ADDENDUM FOUR
Water Treatment Plant
High Service Pump Upgrades
TDEC Project No.: DW20220948
City of Springfield, Tennessee
Bid No. 1250
Griggs & Maloney Project No. 1141-16

To: All Plan Holders
Owner: City of Springfield, Tennessee
Engineer: Griggs & Maloney, Inc.
Project: Water Treatment Plant
High Service Pump Upgrades
File 1141-16
TDEC Project No.: DW20220948

PROJECT NO. 1141-16
DRAWN BY: DSM
CHECKED BY: BWM
APPROVED BY: BWM
DATE: 2023
SCALE: AS SHOWN
SHEET NO. D1.1

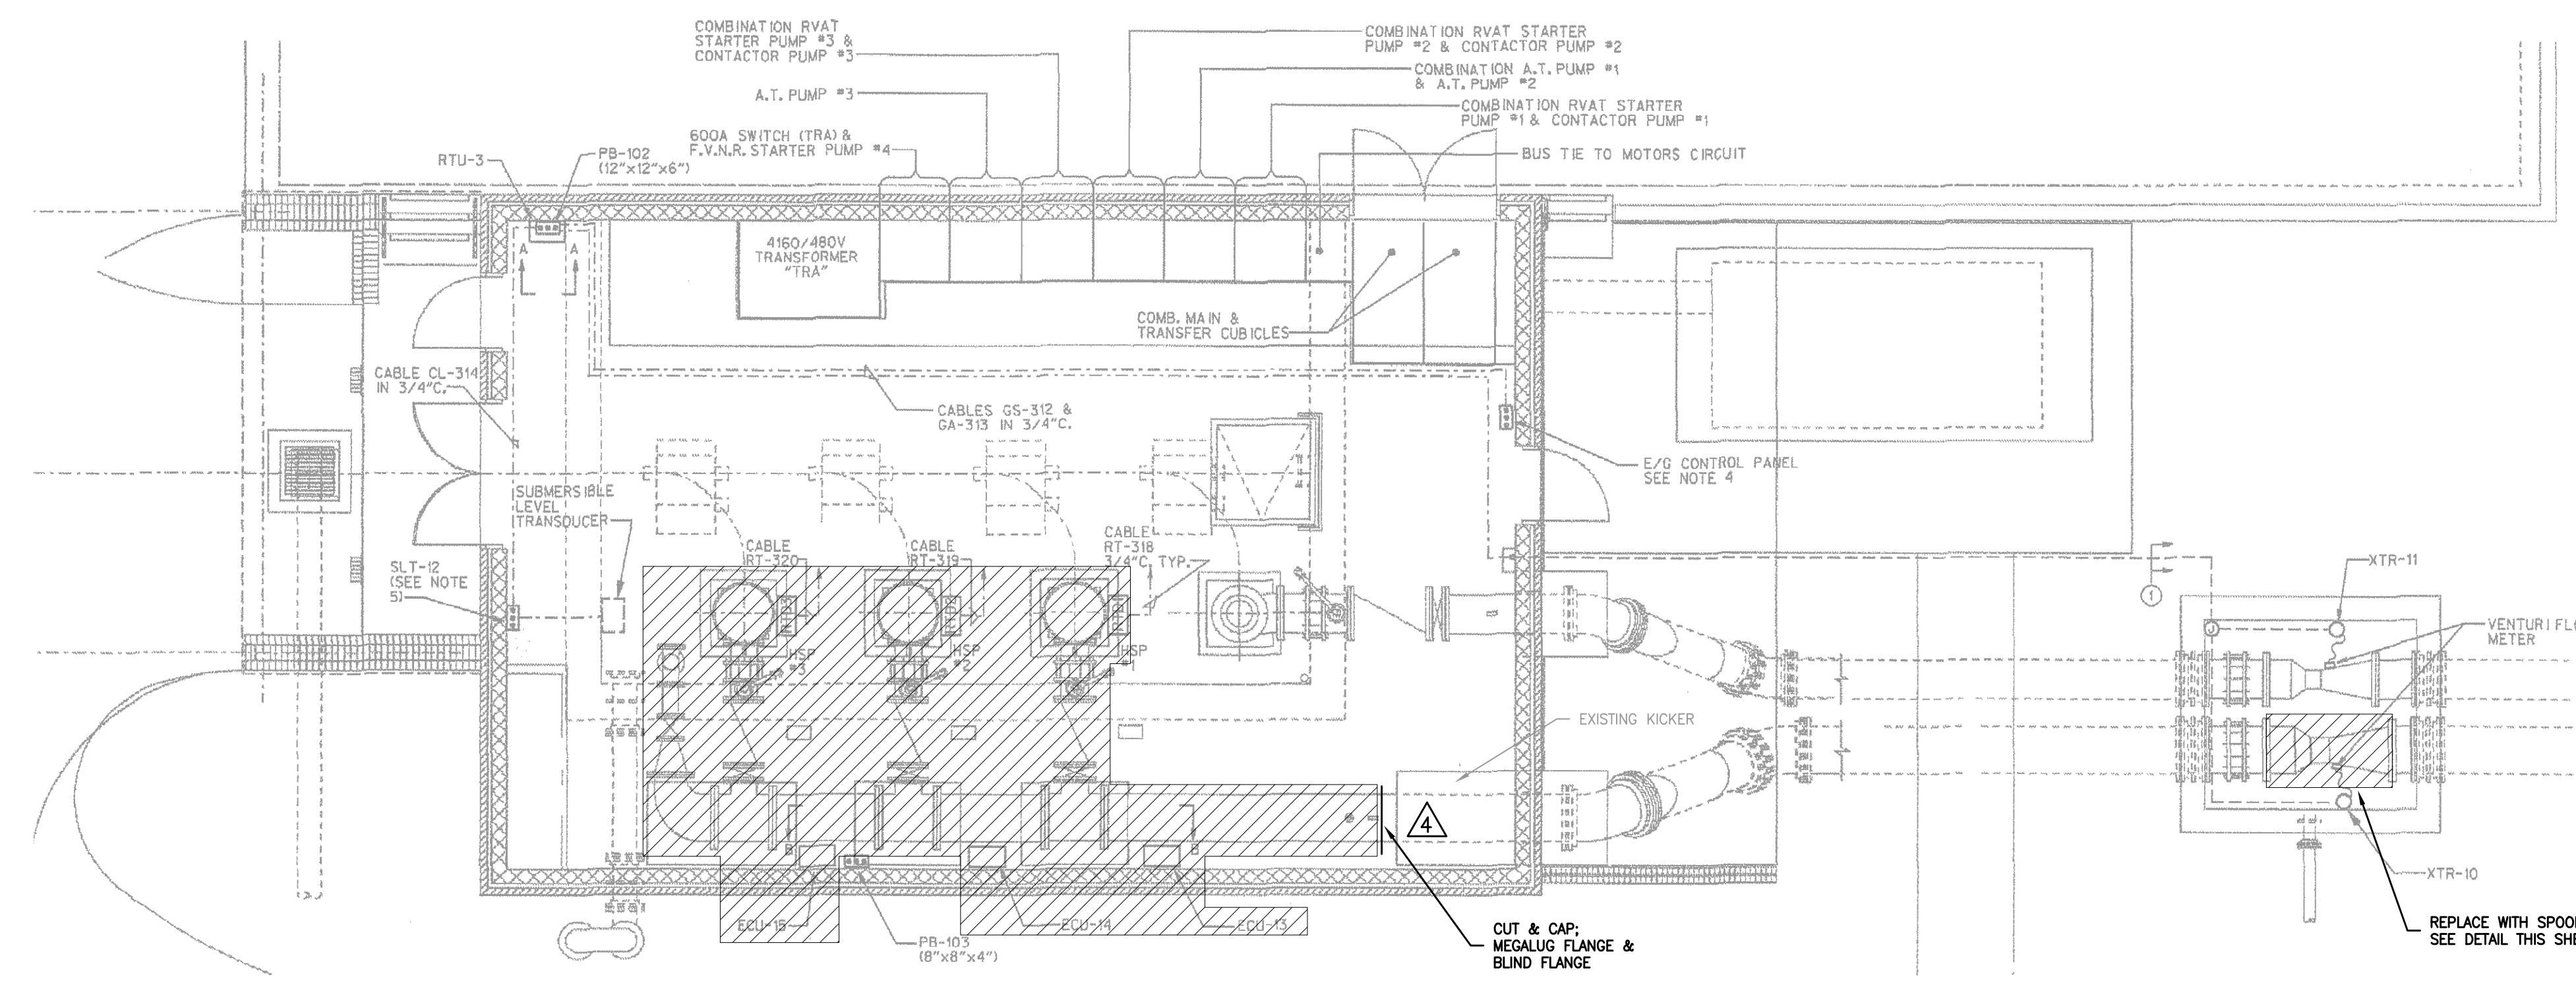
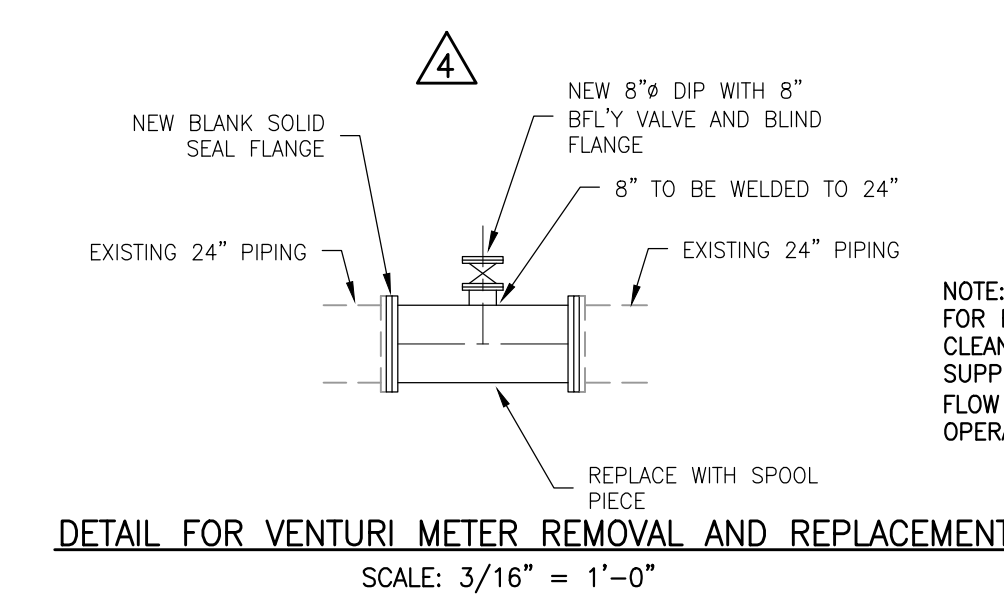
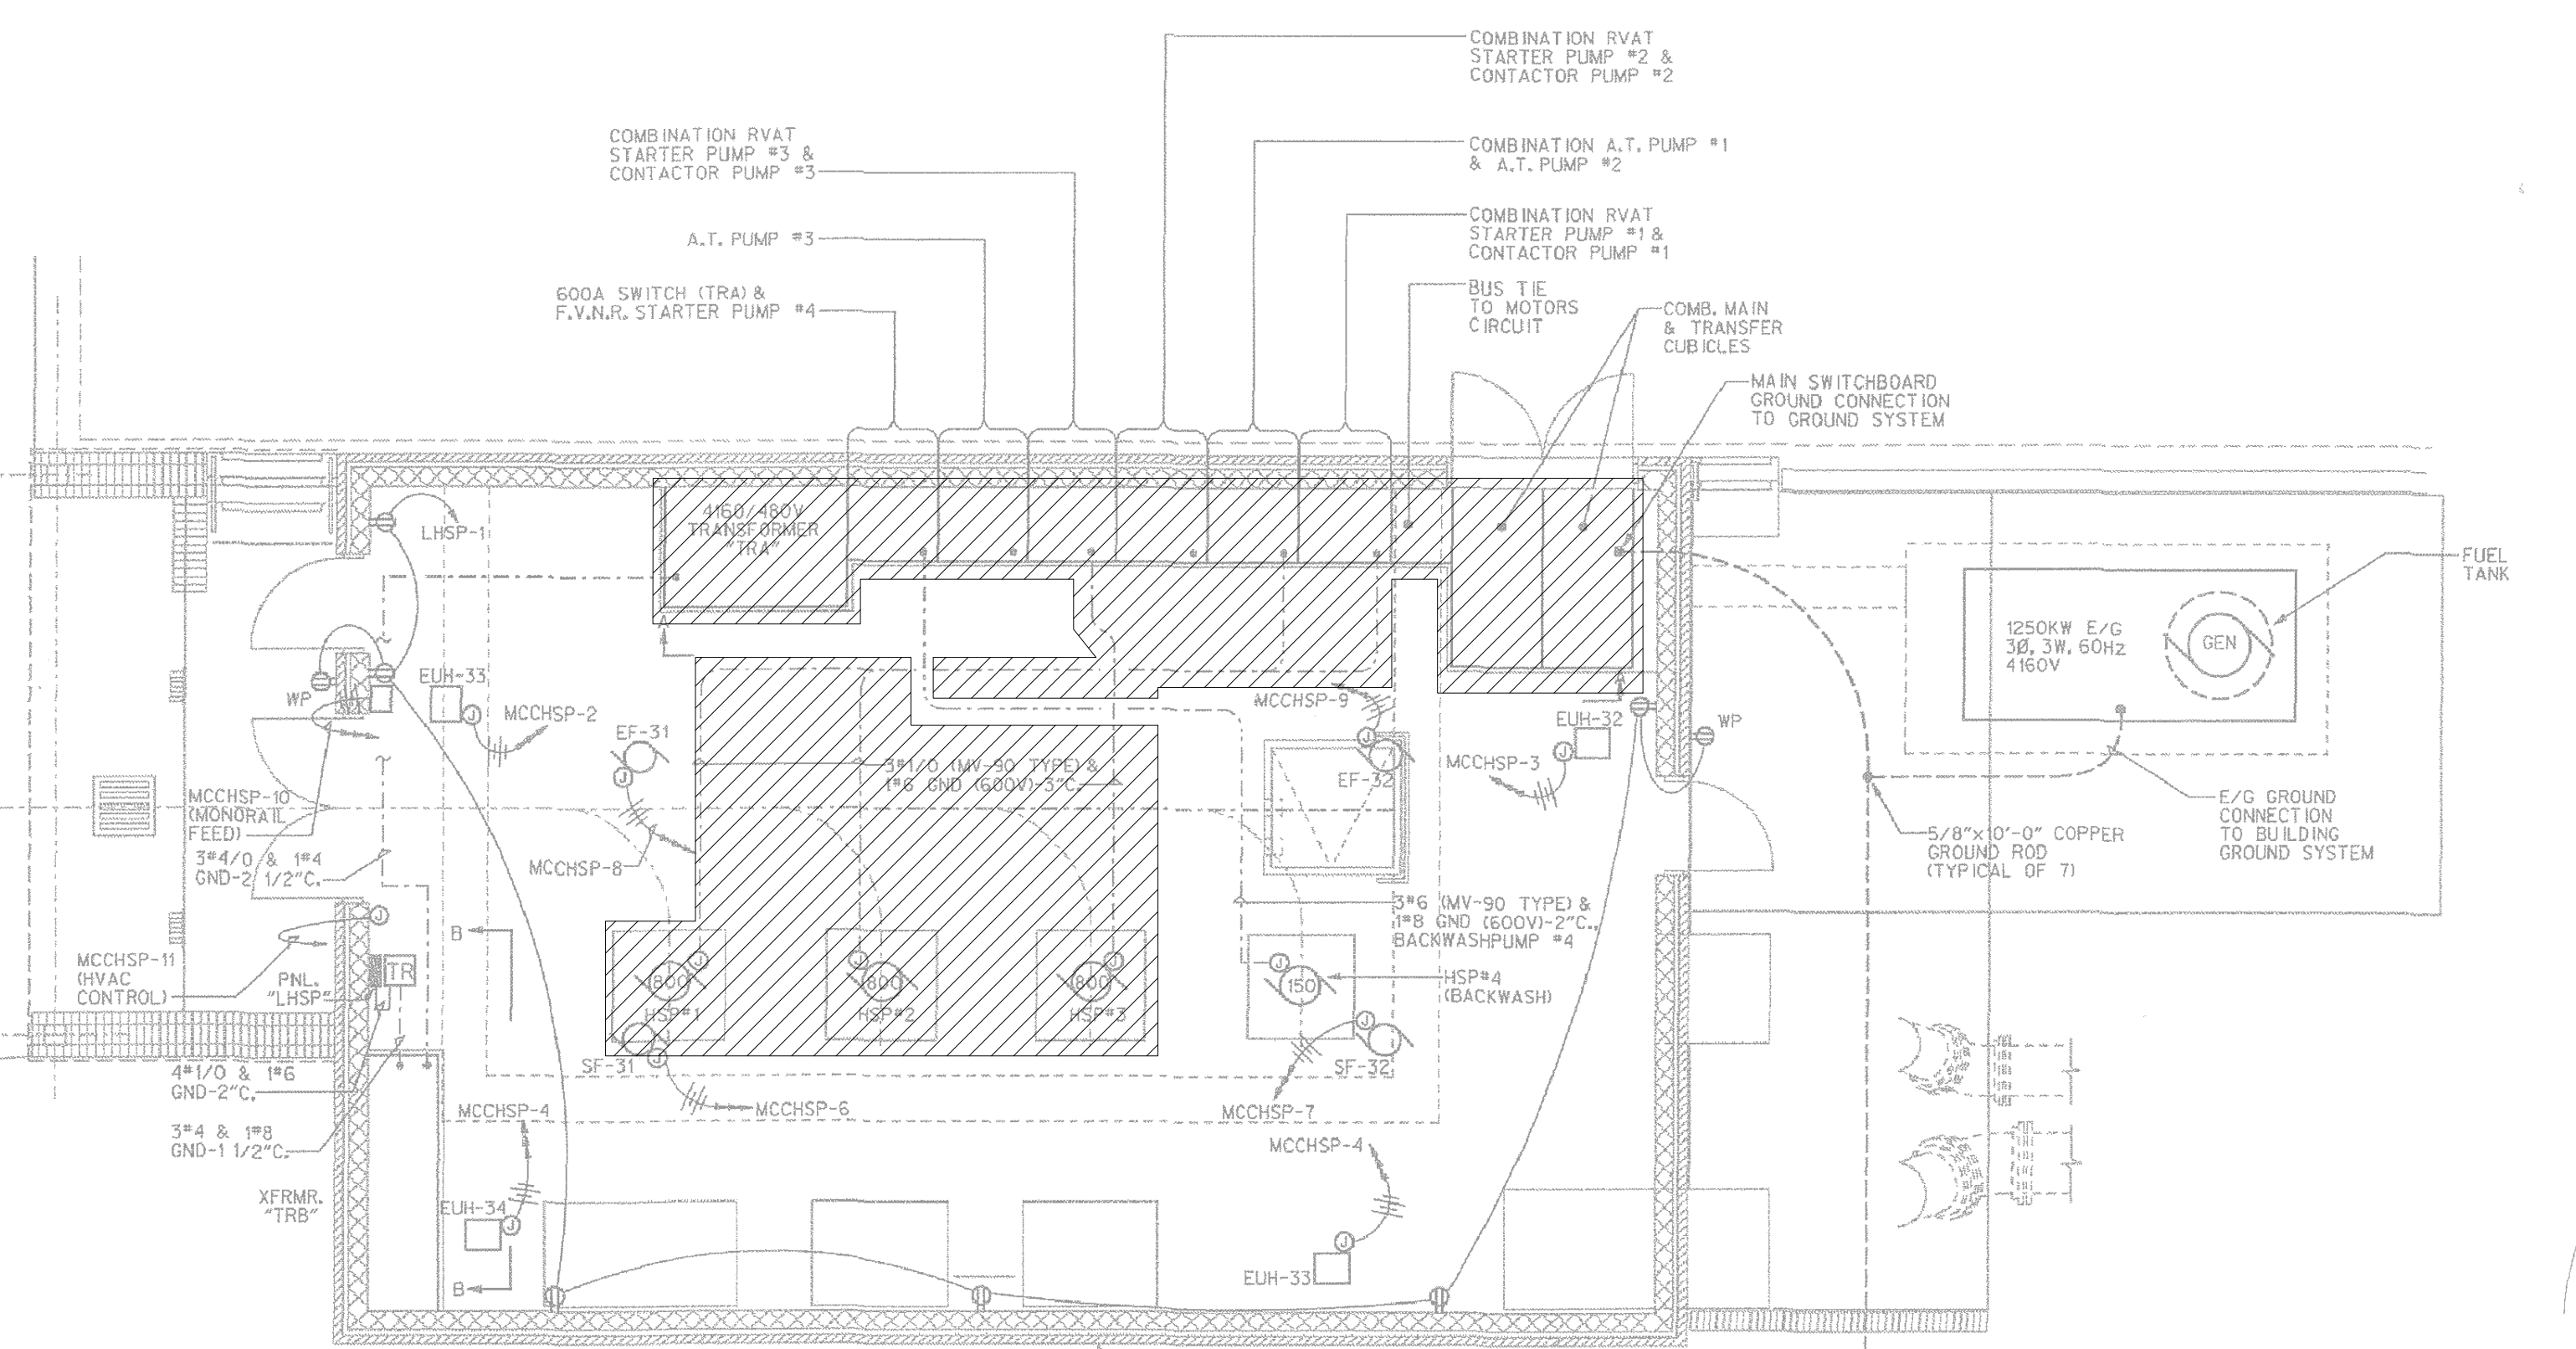
6. **SHEET D1.1 DEMOLITION PLAN – HIGH SERVICE PUMP BUILDING** – See NEW Sheet D1.1 attached.
7. **SHEET M1 NEW CLEARWELL PLAN VIEW** – Redefine ports as one level measuring port and one float port. See re-issued Sheet M1 attached.
